# Southampton to London Pipeline Project

Responses to ExA's Further Written Questions -  
Turf Hill (TH)

Application Document: 8.43

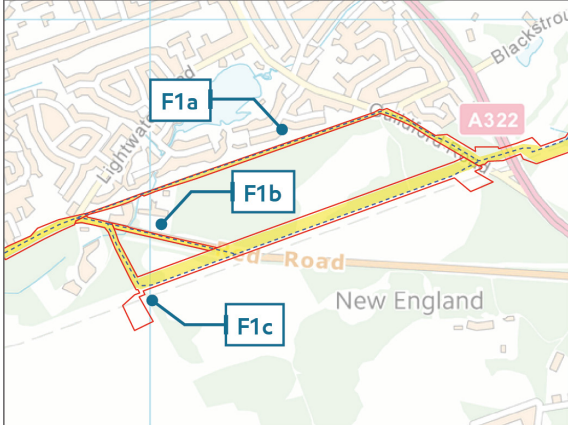
ExQ2	Question:	Applicant response to Question:
	<p><b>Space Officer and SWT were assessed.</b></p> <p><b>ii) Explain how consultation responses and the proximity to residential properties, which is set out as a consideration in paragraphs 2.19.7 – 2.19.10 of NPS EN-4, were weighed into the decision process.</b></p> <p><b>iii) Explain whether the balancing exercise included consideration of the potential impact of tree removal alongside Guildford Road and the impact of Compound 5E on ecology or alternatively the traffic impact on Guildford Road. If not, why not.</b></p> <p><b>iv) Explain whether the balancing exercise took account of the</b></p>	<p>would be desirable; the removal of gorse and pine scrub would be desirable if the area were to be reinstated as heathland; the site compound off Guildford Road should be located in a drier area than the originally proposed location in wet heath; and natural regeneration was the preferred method of reinstatement. The Surrey Heath Open Space Officer confirmed his view after the route was selected.</p> <p>1.2 Given the site-specific and technical knowledge of the ecological features and processes within the Turf Hill unit of the SPA of these organisations, the Applicant has assessed its input to have significant weight when balancing the issues to determine the final selected route.</p> <p>1.3 In response to ii), the Applicant has sought to balance the competing policy guidance within paragraph 2.19.8 of EN-4, <i>‘When designing the route of new pipelines applicants should research relevant constraints including proximity of existing and planned residential properties, schools and hospitals, railway crossings, major road crossings, below surface usage and proximity to environmentally sensitive areas, main river and watercourse crossings. These can be undertaken by means of desk top studies in the first instance, followed up by consulting the appropriate authority, operator, or conservation body if necessary.’</i></p> <p>1.4 The Applicant undertook a desktop assessment and targeted site visits along all the proposed corridors prior to the corridor consultation. Preliminary environmental information, constraints such as current land uses and proposed allocations, were all plotted on a digital mapping tool. Following consultation, the Applicant developed the routing of the pipeline within the preferred corridor (Corridor J), leading to the identification of the three options in the Turf Hill Area (F1a, F1b and F1c) considered in the statutory consultation. In parallel, the Applicant engaged with Natural England, the Surrey Heath Open Space Officer (in his role as the Officer responsible for the management of Turf Hill) and Surrey Wildlife Trust. All this engagement, research, and consultation was considered in conjunction with the results of walkover surveys in determining the relative sensitivity of the ecological constraints with the residential constraints of each alternative route option.</p>

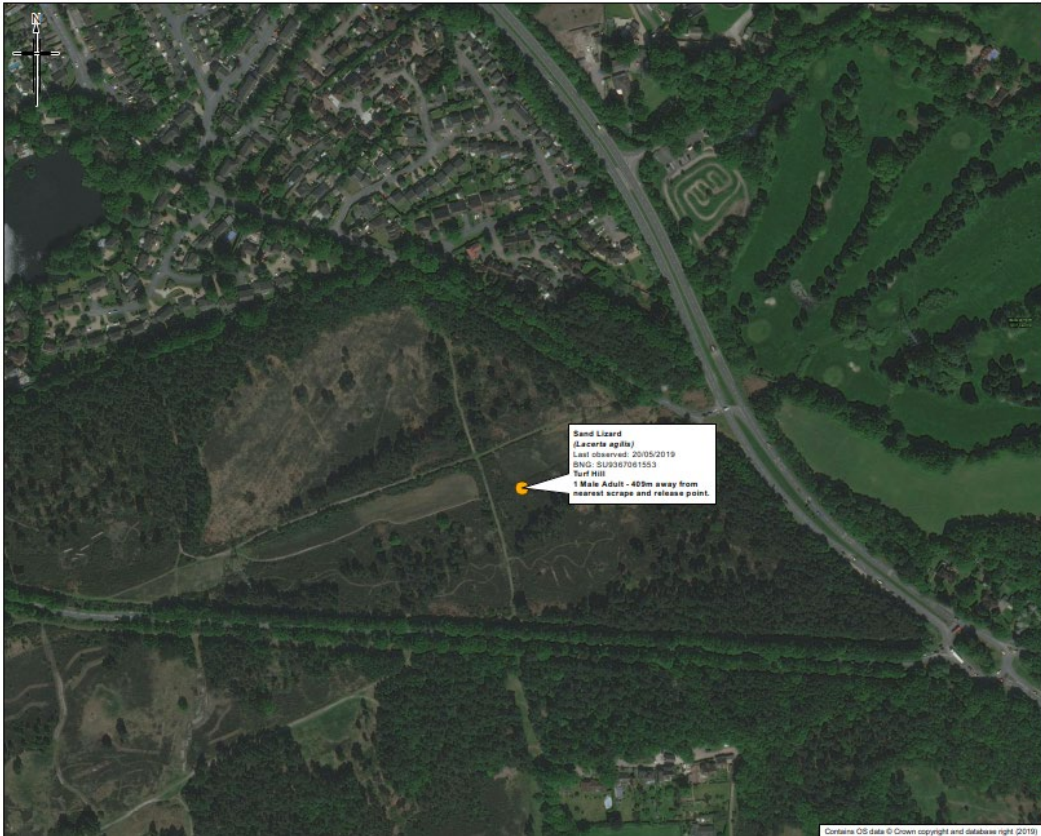
<p>TH.2.7</p>	<p>Map 6 of the Turf Hill Park Management Plan (Appendix 8 of <a href="#">[REP3-013]</a>) shows the sand lizard release area and breeding area in compartment 6. This is separate from compartment 2 which comprises dry heathland with wooded blocks and extends</p>	<p>1.1 The Applicant has not been involved in the release of sand lizards at Turf Hill but believes that it is the intention of the release programme for sand lizards to recolonise large areas of the SSSI. This appears to be supported by the Surrey Heath Turf Hill Management Plan (Surrey Heath Borough Council, 2015) (presented in Appendix 8 of <a href="#">(REP3-013)</a>). Appendix 3 of that document, "Turf Hill Sand Lizard Re-Introduction Project", states that, '<i>to complement these specialist works the ongoing management to maintain a heathland mosaic of trees, scrub and heathers would continue across the whole site</i>'. This indicates that the management of the whole of Turf Hill would complement the sand lizard re-introduction programme.</p> <p>1.2 It is not clear why the ExA has highlighted the issue of four-year cycle cutting. The objective of the cutting regime appears to be to prevent tree growth beneath the power cables. However, regular cutting of heathland is a common practice across the SPA, is compatible with reptiles such as</p>

ExQ2	Question:	Applicant response to Question:
	<p>along the route of the pylons / option F1c.</p> <p>Compartment 2 is described as differing “from the other areas of dry heathland on site being linear in shape and regularly cut on a 4-year cycle since 1994. Situated beneath the high-power cables that cross the site this compartment was, prior to 1994, cut on an ad-hoc basis by National Grid in order to keep the power cables free of trees”.</p> <p>i) Explain whether Sand Lizards that were reintroduced to Turf Hill likely to have remained in or close to the original release area or will they have spread out from the original release site and if they have how far are</p>	<p>sand lizard (unlike pipeline installation) and helps to maintain a healthy mixed age population of heathland plants. Reference to cutting and mowing can be found in the Surrey Heath Turf Hill Management Plan (Surrey Heath Borough Council, 2015) as this helps maintain the heathland habitat favoured by sand lizard.</p> <p>1.3 In response to i), the sand lizard release site is monitored regularly by the Surrey Amphibian and Reptile Group (SARG). The most recent records of sand lizard recorded adult female and juvenile individuals in September 2019, showing that the population is still present and breeding at the original release site. SARG’s records of sand lizard in May 2019 also indicate that they have already spread out from the release site and have travelled over 400m, which is a significant distance for a reptile. (See sketch maps below).</p> <p>1.4 In response to ii), the Applicant would like to clarify that option F1c is almost entirely outside Compartment 2. Compartment 2 is the area beneath the HV power lines and subject to the four-year cycle cutting to prevent tree growth beneath the power lines. F1c occupies the largely heathland habitat to the north of Compartment 2 due to the restrictions of working under or close to the power lines.</p> <p>1.5 The SARG data show that sand lizard have dispersed from the original release site and utilised the habitat within F1c and Compartment 2 having crossed the well-used path.</p> <p>1.6 The habitat along F1c has been assessed as being highly suitable for sand lizard, and this is explained in ES Appendix 7.11: Reptile Factual Report (<b>Application Document <a href="#">APP-092</a></b>).</p> <p>1.7 Therefore, combined with the SARG records, the Applicant believes the ExA’s suggestion, ‘<i>that route F1c is as unsuitable for sand lizards as other parts of Turf Hill including the proposed route option</i>’ is incorrect.</p>
